**Proposal for amendments to ECE/TRANS/WP.29/GRVA/2020/32 and
ECE/TRANS/WP.29/GRVA/2020/33**

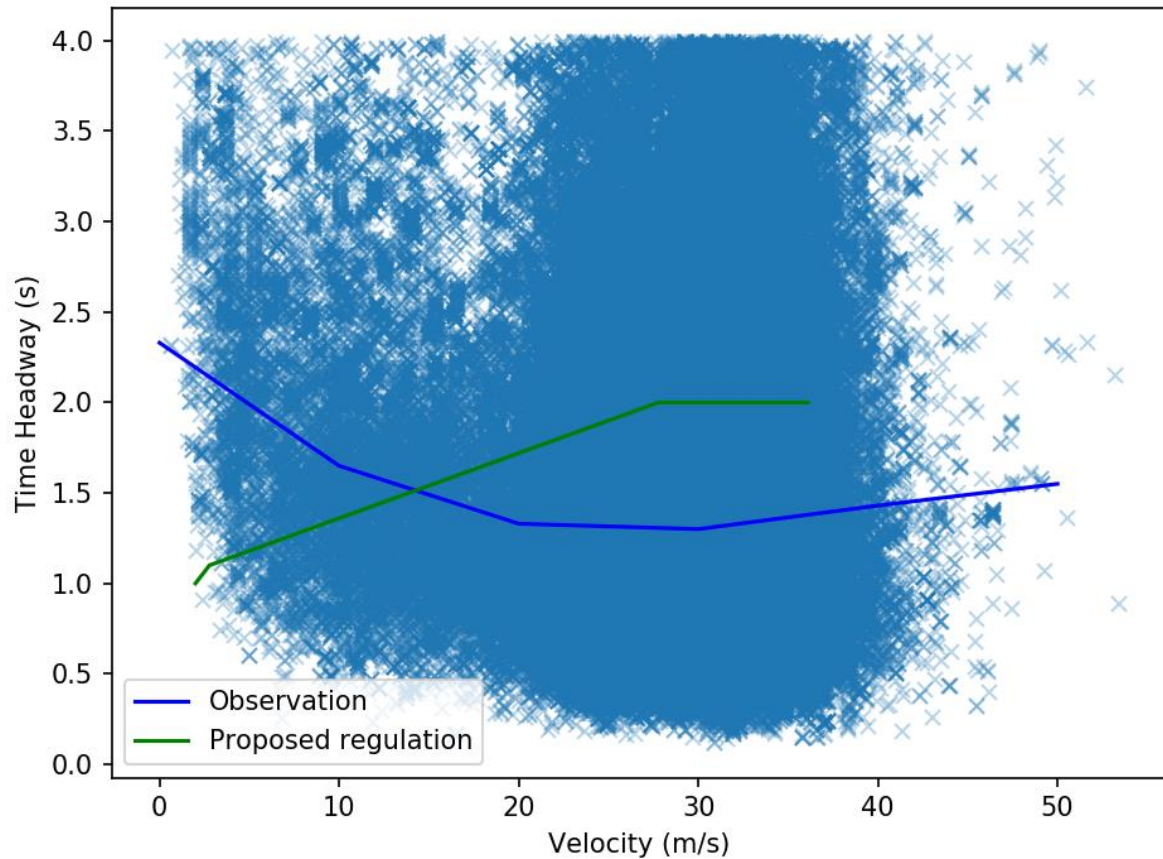
While it is obvious that with the increase in the speed the distance has to increase, it is not so obvious that also the time-gap has to increase. We therefore compared the relationship between speed and time-gap introduced by the amendment with what observed by human drivers (derived from the highD database of traffic data collected on German motorways).

The comparison is shown in the figure above in which the blue line is the median line from all the observations (represented by the blue dots) while the green line is the regulation requirement. The two lines show an opposite trend. It is worth noticing that the increase of the blue line in the right part of the diagram is due to the fact at high speed the vehicle is not always affected by the vehicle ahead. So this part of the diagram include cases in which the vehicle ahead is very far away and this contributes to the new increase in the time-gap.

While AVs do not necessarily have to reproduce human behaviour, it would be important to understand the reason to choose those specific values.
